Bay Arenac ISD Dining Room Addition
and Interior Renovations
Bay City, Michigan

ADDENDUM NO. 4
Date: August 5, 2026
TSSF Project # 2538

This addendum authorizes the following revisions to the plans and specifications for the above-named project and will be considered fully a part of said documents.

A0.1

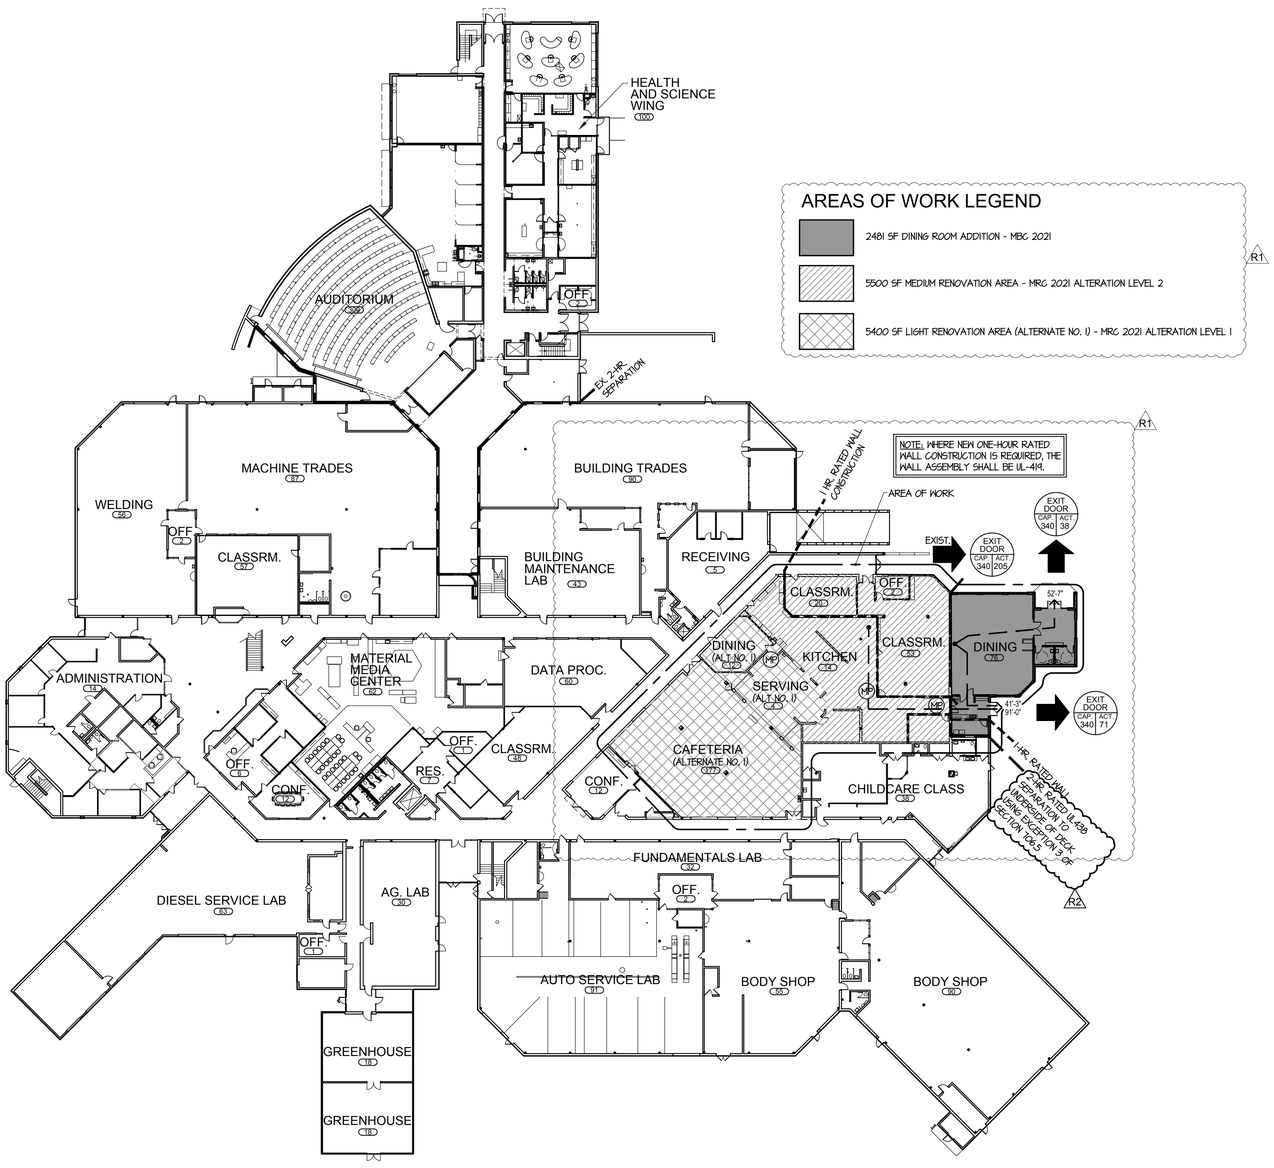
Item A2: **See revised sheet A0.1 (re-issued):** See revisions shown clouded.
A. Added (FULLY SPRINKLERED) note to the addition as this was the original intended design.
B. Added Allowable Building Height and Area table for the addition.
C. Added non-opaque information to energy code table.
D. Added note regarding direction and exception for 2-hr fire separation at addition.

ALLOWABLE BUILDING HEIGHT	ALLOWABLE BUILDING AREA
3 Story, 75'–0"	58,000 Sq. Ft. (ADDITION ONLY)

4 A6.0 WALL SECTION
SCALE: 3/4" = 1'-0"

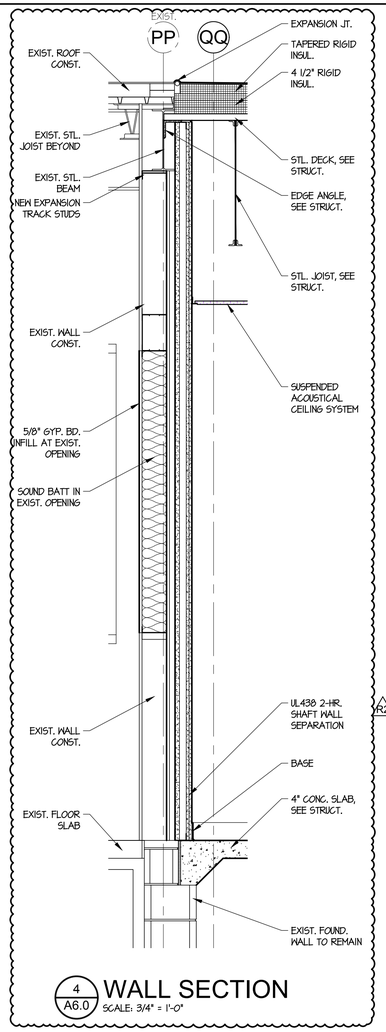
Item A4: **See revised sheet A6.0 (re-issued):** See added wall section 4/A6.0 for 2-hr wall separation.

MAIN FLOOR PLAN - POWER
1/8" = 1'-0"

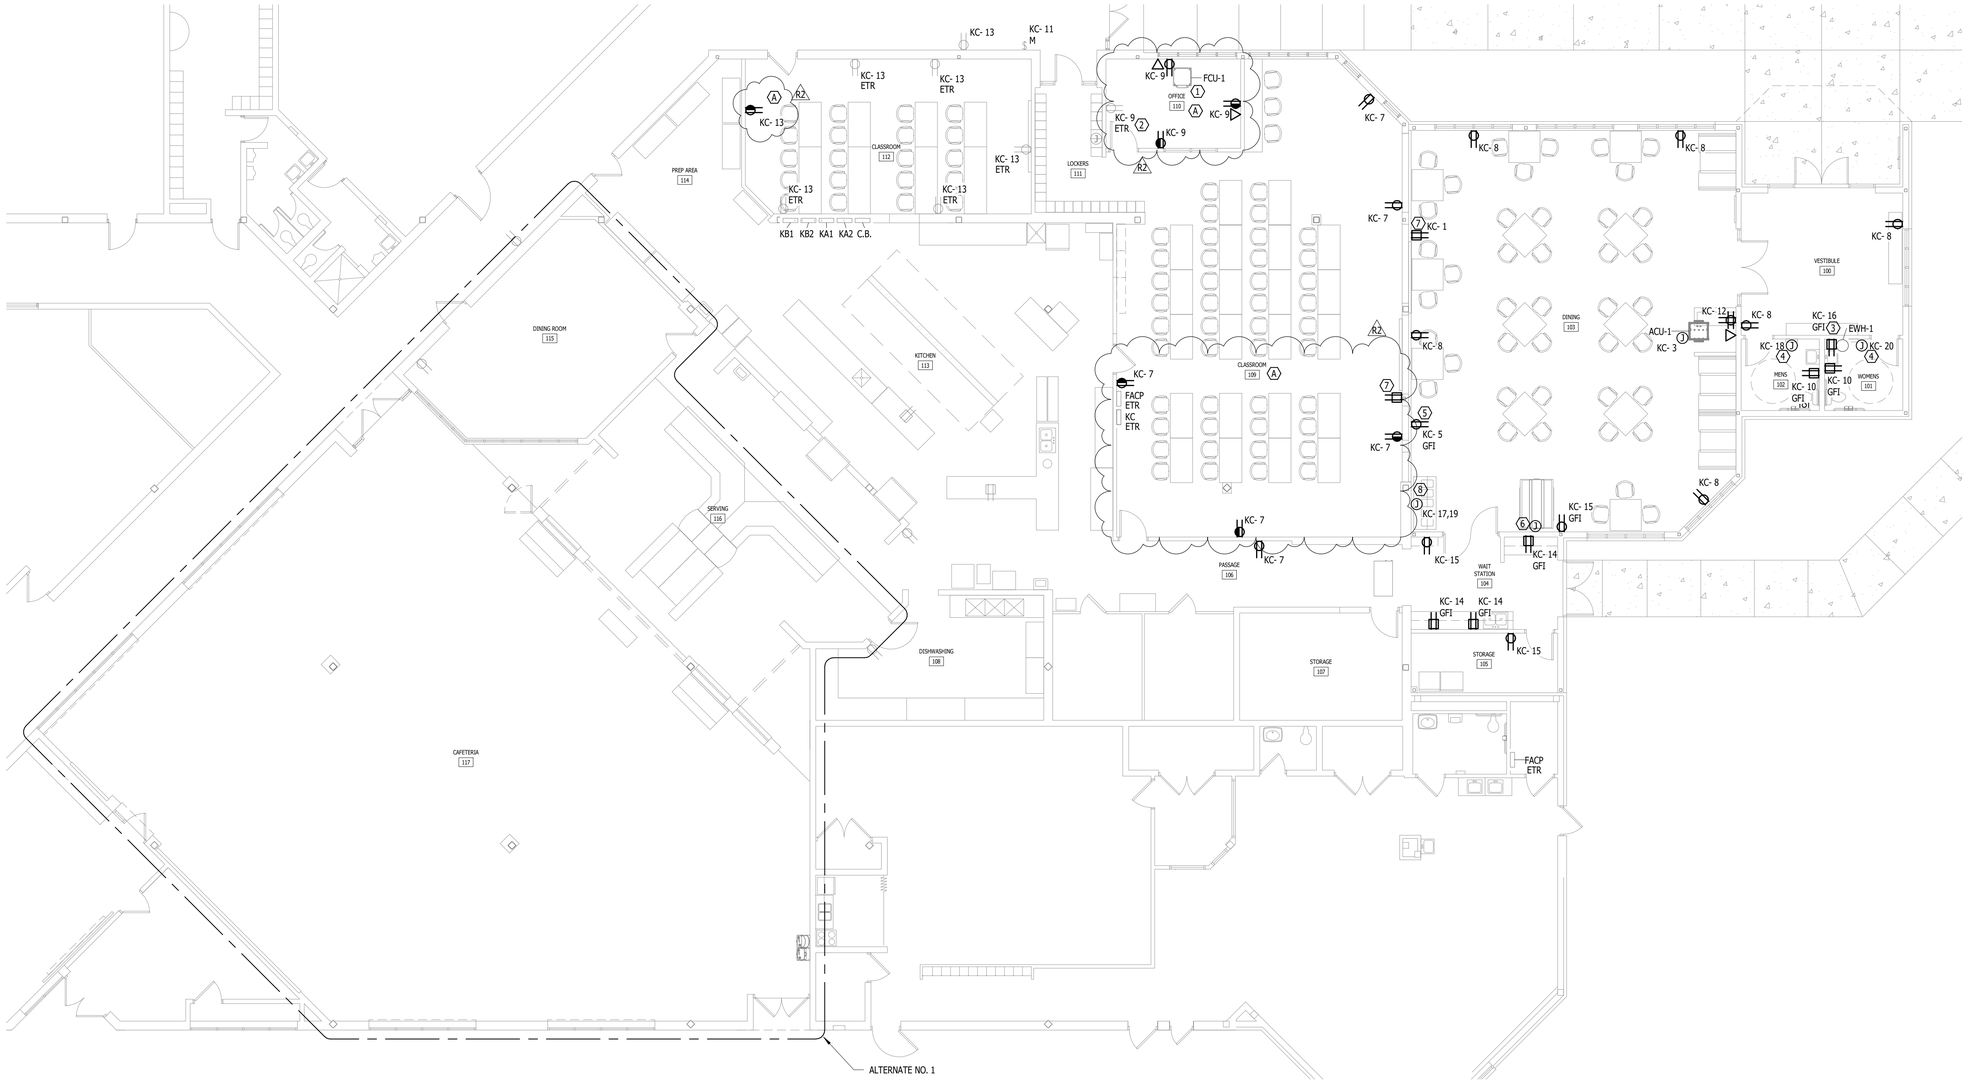
Item E2: **See revised sheet E1.0 (re-issued):** Revised Receptacle Control Matrix and notations on plan.

KEYNOTE	TYPE	SENSOR	FULL OFF TIME	NOTES
A	OCCUPANCY SENSOR	AUTO ON/OFF	20 MINS	RECEPTACLE CONTROL SHALL ONLY CONTROL SPLIT-CIRCUIT RECEPTACLES.

SPLIT-CIRCUIT RECEPTACLE

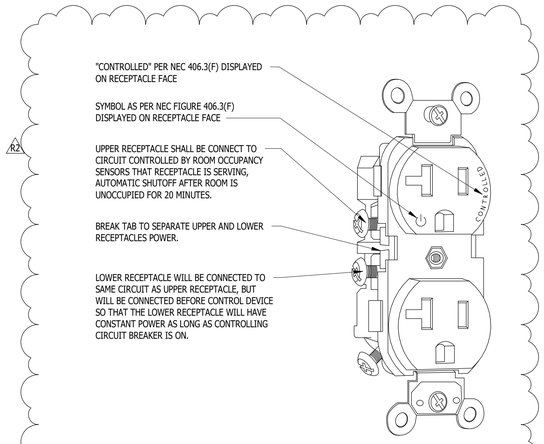
Item E3: **See revised sheet E5.0 (re-issued):** Added Split-Circuit Receptacle Detail
